UNITED STATES PATENT AND TRADEMARK OFFICE

APPLICATION NO.	FILING DATE	FIRST NAMED INVENTOR	ATTORNEY DOCKET NO.	CONFIRMATION NO.
10/813,924	03/31/2004	Byeong-Jun Lee	AIP3.001AUS	5060

Office Action Summary

DETAILED ACTION

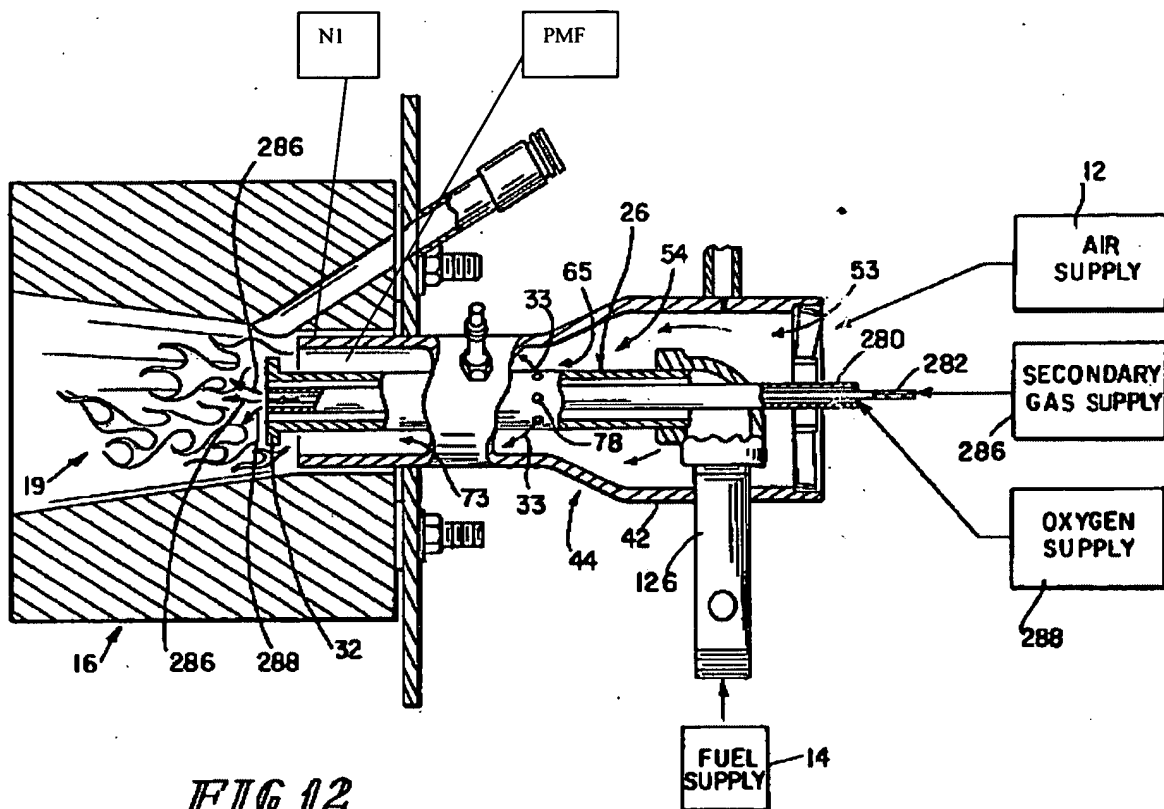
With respect to claim 1, **Cummings** teaches a method of combustion, comprising: supplying a premixed fuel PMF through at least one nozzle N1 into a combustion chamber, the premixed fuel comprising an oxidizer 12; supplying a non-premixed fuel 286 through at least one nozzle 282 into the combustion chamber; and simultaneously burning the premixed and non-premixed fuel in the combustion chamber. See particularly **Figure 12** of Cummings.

With respect to claim 3, **Cummings** teaches that the premixed fuel PMF is a mixture comprising an oxidizer 12 and at least one combustible material 14. See particularly **Figure 12** of Cummings.

With respect to claim 4, **Cummings** teaches that the non-premixed fuel comprises at least one combustible material 286. See particularly **Figure 12** of Cummings.

With respect to claim 5, **Cummings** teaches that the method further comprises supplying an oxidizer 288 substantially free of a combustible material through at least one nozzle 280 into the chamber. See particularly **Figure 12** of Cummings.

With respect to claim 15, **Cummings** teaches that the at least one nozzle N1 for the premixed fuel and the at least one nozzle 282 for the non-premixed fuel 286 are formed in a single piece fuel injector. See particularly **Figure 12** of Cummings.

FIG. 2

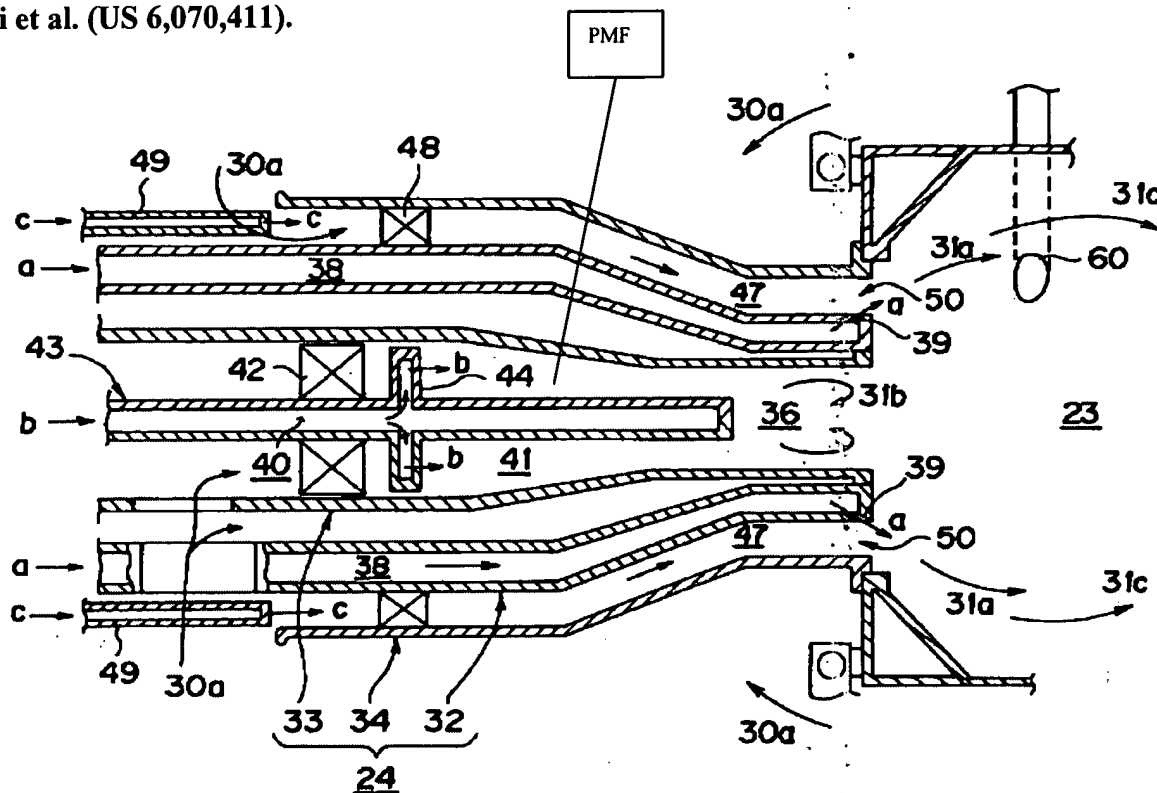
With respect to claim 1, Iwai teaches a method of combustion, comprising: supplying a premixed fuel PMF through at least one nozzle 33 into a combustion chamber, the premixed fuel comprising an oxidizer; supplying a non-premixed fuel A through at least one nozzle 32 into the combustion chamber; and simultaneously burning the premixed and non-premixed fuel in the combustion chamber. See particularly Figure 2 of Iwai.

With respect to claim 3, **Iwai** teaches that the premixed fuel PMF is a mixture comprising an oxidizer and at least one combustible material. See particularly column 9 lines 59; and **Figure 2** of **Iwai**.

With respect to claim 4, **Iwai** teaches that the non-premixed fuel A comprises at least one combustible material. See particularly column 9 line 45; and **Figure 2** of **Iwai**.

With respect to claim 15, **Iwai** teaches that the at least one nozzle 33 for the premixed fuel and the at least one nozzle 32 for the non-premixed fuel are formed in a single piece fuel injector 24. See particularly **Figure 2** of **Iwai**.

FIG. 1

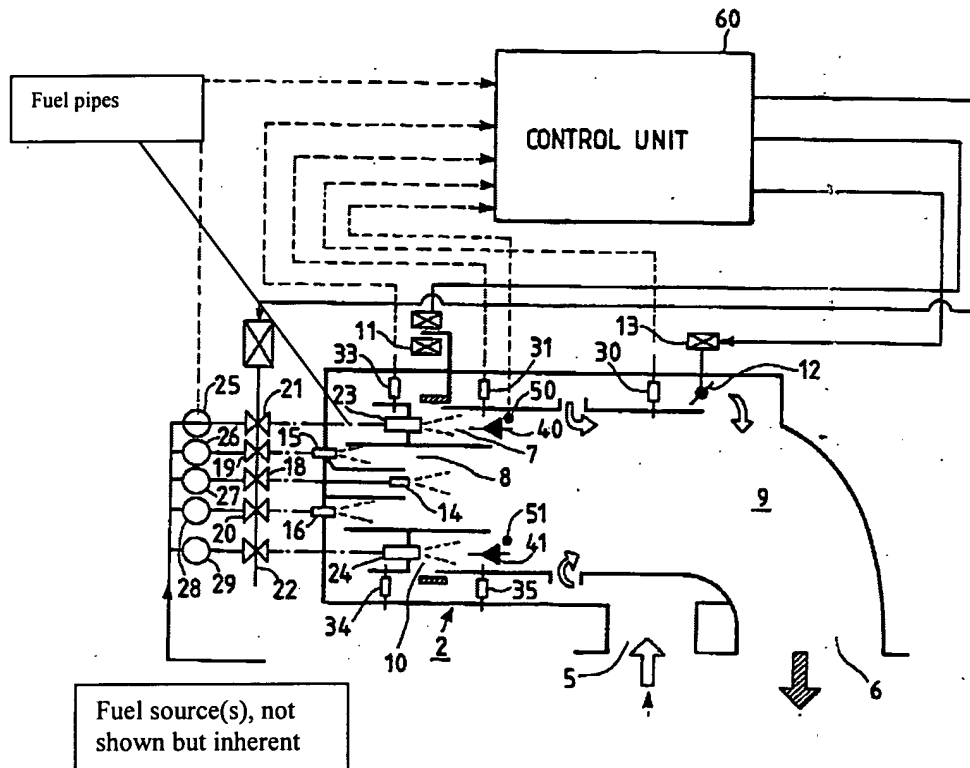
With respect to claim 17, **Ohyama** teaches a burner, comprising: a combustion chamber 2; at least one premixed fuel nozzle 23 configured to supply a premixed fuel into the chamber, at least one non-premixed fuel nozzle 14 configured to supply a non-premixed fuel into the chamber; at least one premixed fuel pipe (shown but not labeled) connecting the at least one premixed fuel nozzle 23 with a premixed fuel source (not shown but inherent); at least one non-premixed fuel pipe (shown but not labeled) connecting the at least one non-premixed fuel nozzle 14 with a non-premixed fuel source (not shown but inherent), and a controller 60 to control operation of the burner, wherein the controller is configured to operate the burner in one or more

modes, in which the premixed fuel is supplied to the chamber through the at least one premixed fuel nozzle 23 and the non- premixed fuel is supplied to the chamber through the at least one non-premixed fuel nozzle 14. See particularly **Figure 1** of Ohyama.

With respect to claim 19, **Ohyama** teaches that the burner comprises a plurality of premixed fuel nozzles (23, 24), and wherein the plurality of premixed fuel nozzles are arranged so as to surround the at least one non-premixed fuel nozzle 14. See particularly **Figure 1** of Ohyama.

With respect to claim 20, **Ohyama** teaches that at least a portion of the plurality of premixed fuel nozzles (23, 24) is located on an imaginary circle (not shown but inherent since it is a typical arrangement used in the art) surrounding the at least one non-premixed fuel nozzle 14. See particularly **Figure 1** of Ohyama.

With respect to claim 21, **Ohyama** teaches that the at least one non-premixed fuel nozzle 14 is located on the center of the imaginary circle. See particularly **Figure 1** of Ohyama.
